I sent out a questionnaire to some very prominent engineers regarding the use of angle irons in Bay Area seismic retrofit work. A huge number of retrofits in the Bay Area have been and are still being retrofitted with angle irons. The purpose of this questionnaire was to evaluate their effectiveness. The letters in front of the "yes" and "no" are the initials of the engineers.

### Additional comments from engineer R after reading engineer K's engineering analysis

Comments from engineer K

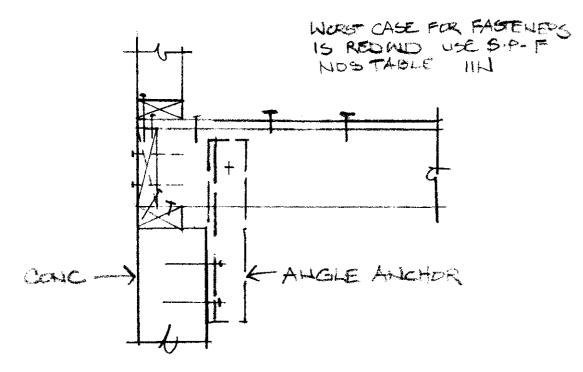
I am attaching further calculations looking at how much earthquake load can be transferred in to the angle iron with a rim joist, and without blocking or rim joist. The numbers range between 300# and 600#, and rely more heavily on the nailing of the floor sheathing to the top of the joist when blocking is not present.

I am less concerned with the numbers and more concerned that the angle iron will create a hard spot and cause the joists to be split horizontally at mid-depth in the weak direction when the joist is pulling away from the angle. This will not likely cause collapse of anything, but could leave damage. We saw some of this type of this splitting in a diaphragm test at UC Irvine.

## FOUNDATION ANGLE ANCHOR W/O RIM OR BLKG

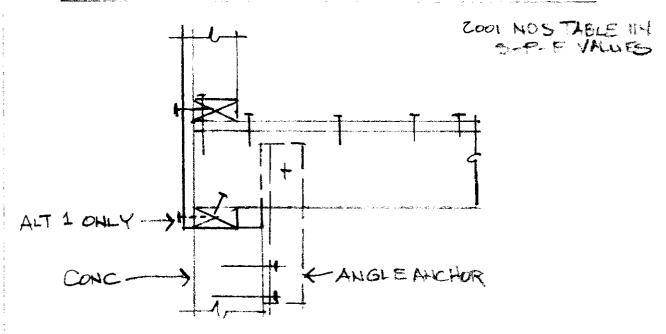
ALT 1 - EXT SHEATHING TRANSFERS ALT 2 - EXT SHEATHING LOAD TO SILL PLATE

SUM 581 #

NOTE: IN WEAR DIRECTION, CROSS- GRAIN TENSION FAILURE OF JUST IS LIKELY - TOP SAN JOT FAILURE IN FORADENTI TESTS.
